THE ILLINOIS STATE TOLL HIGHWAY AUTHORITY

DESIGN BULLETIN No. 20-02

SUBJECT: Noise Abatement Wall, Parapet, and Concrete Barrier Mounted Sign Supports

STANDARD F11-06

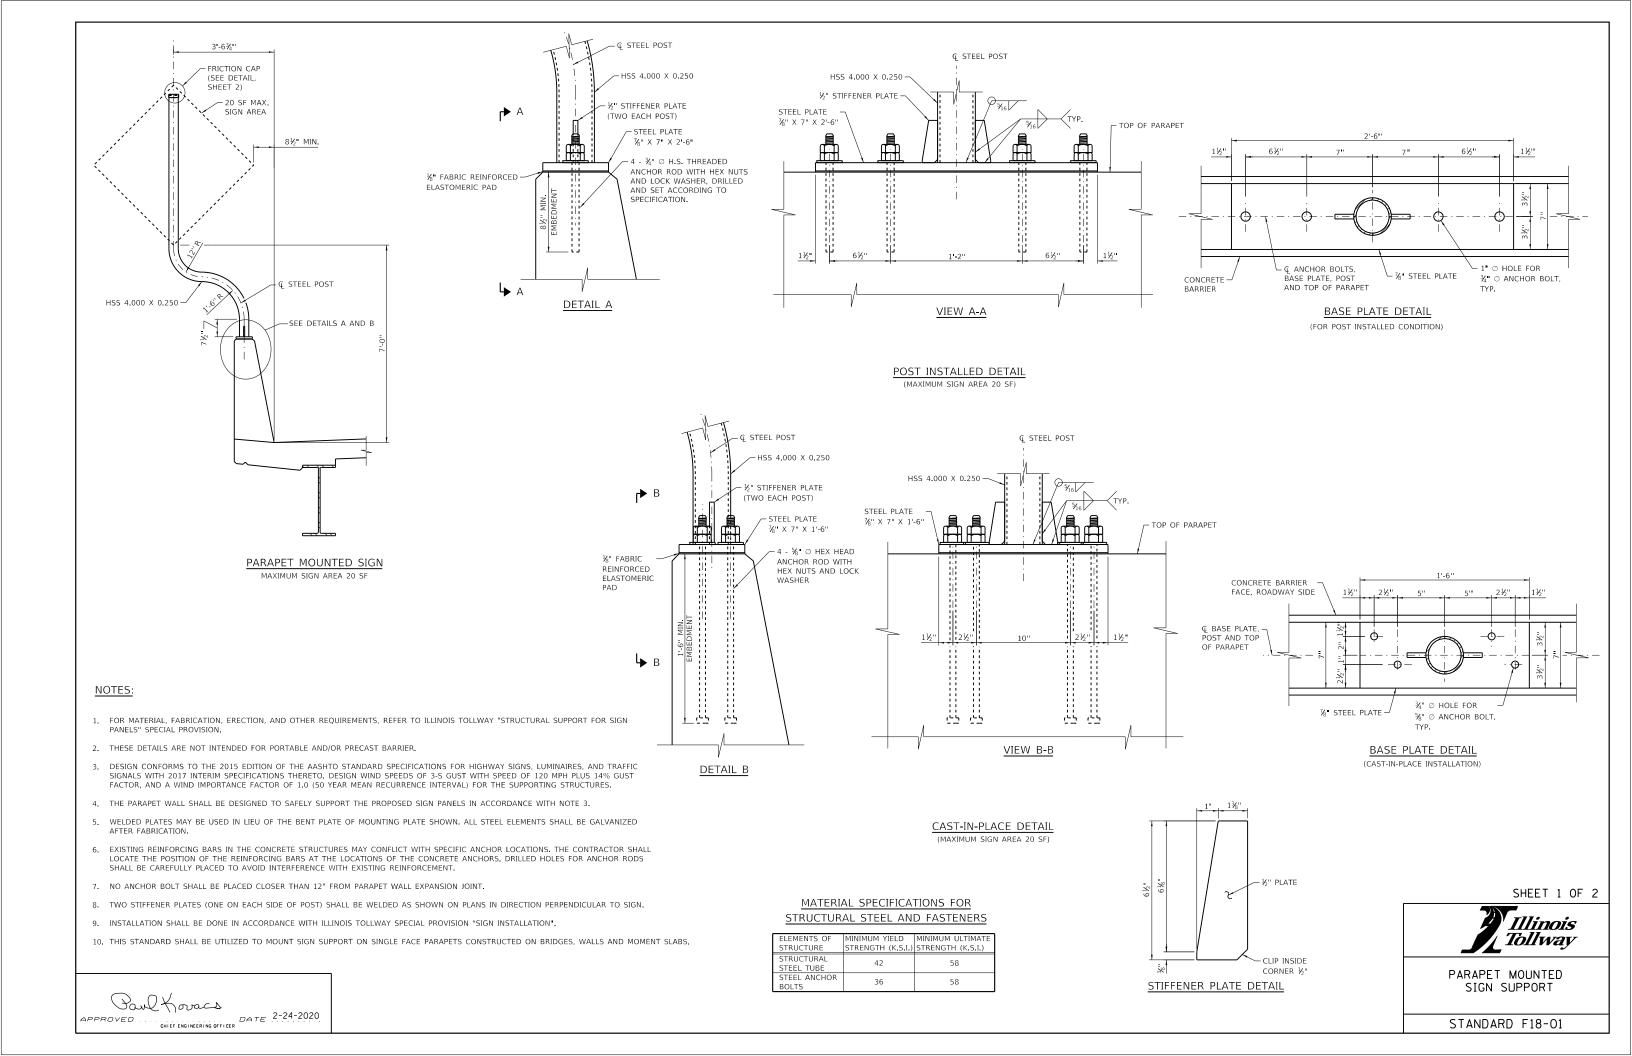
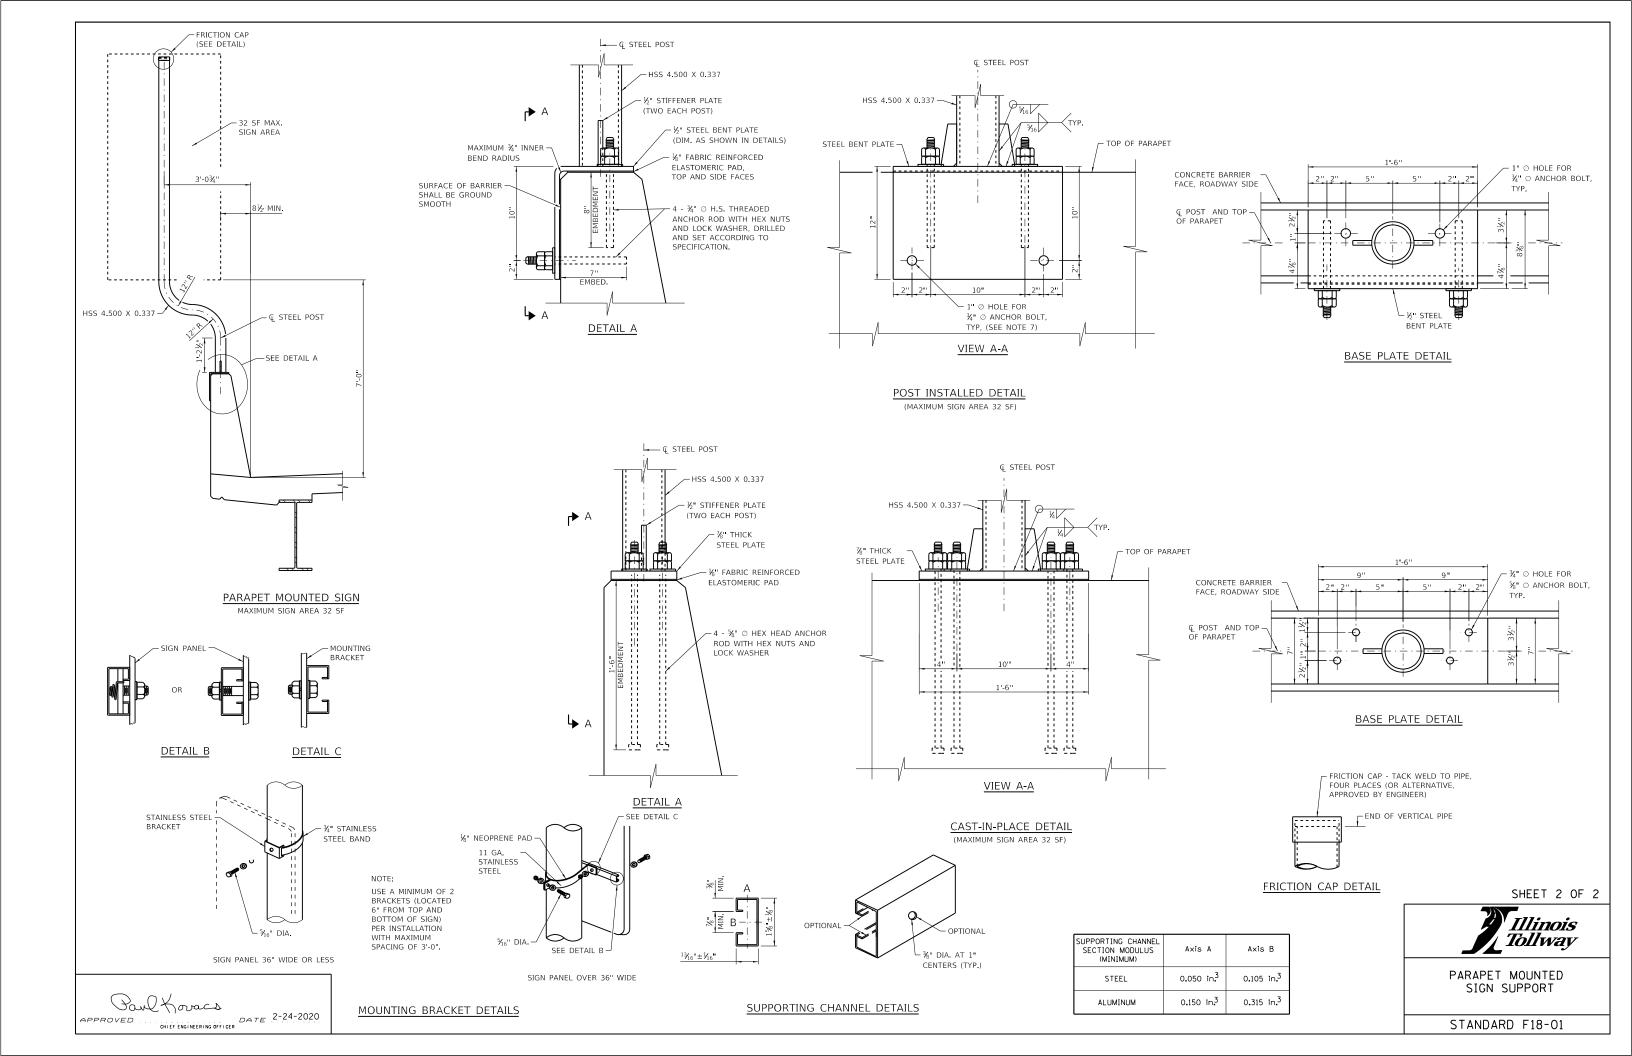
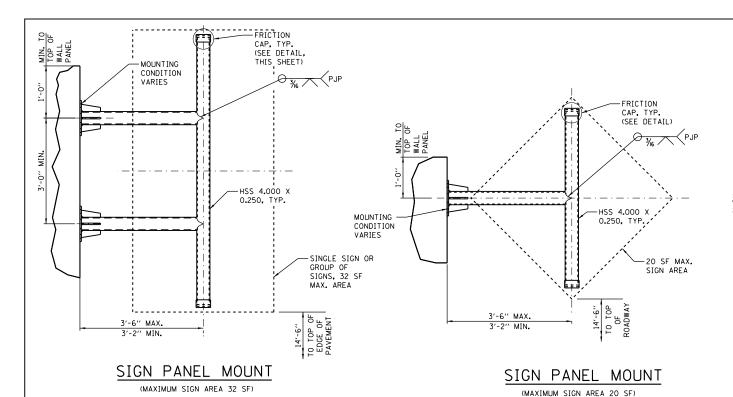
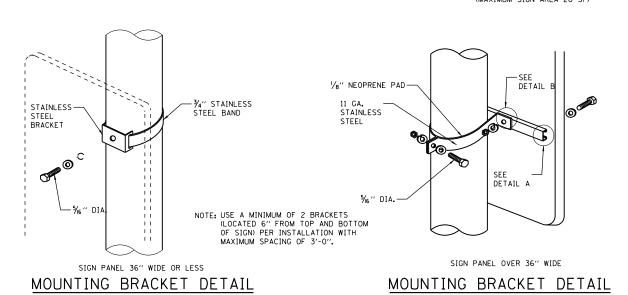
Milepost Marker: The existing milepost marker assembly had some premature failures in the welds. Sign Standard F11 has been revised to strengthen the connection of the post to the base utilizing T-fittings in addition to the welded joint.

STANDARD F19-01

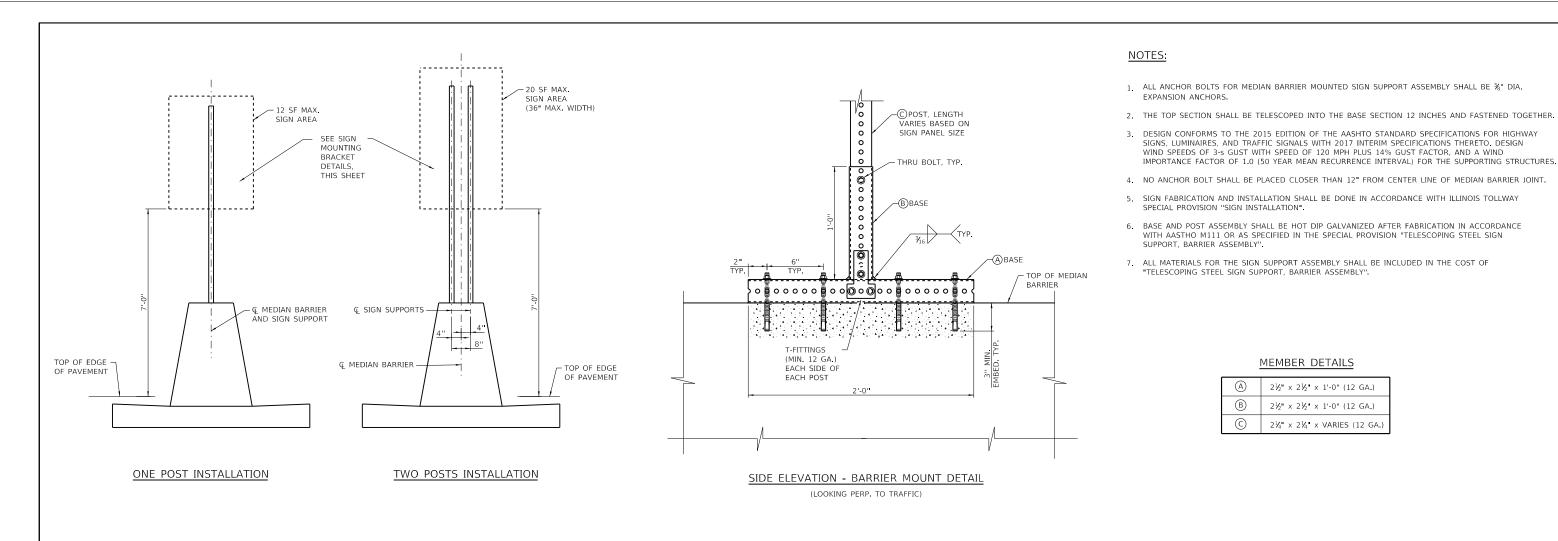
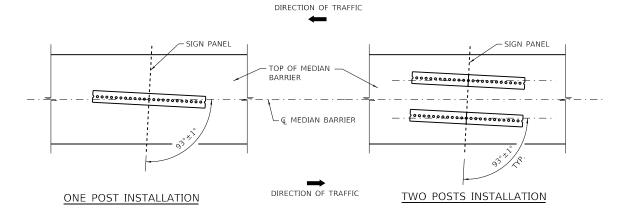
Noise Abatement Wall (NAW) Mounted Sign Support: The 2019 Structure Design Manual specifies a minimum NAW offset of 29" from the front face of NAW to the toe of barrier. The specified 29" offset creates insufficient space to install roadway signs between the roadway and NAW. The 2019 Roadway Signing and Pavement Marking Guidelines Section 2.15 has been updated to allow mounting signs to new NAWs provided that the NAW designs account for the signs and mounting heights. The mounting heights shall be a minimum of 14'-6" above the roadway level. Where the mounting is above the NAW height, the sign support bracket shall be mounted on the NAW posts.
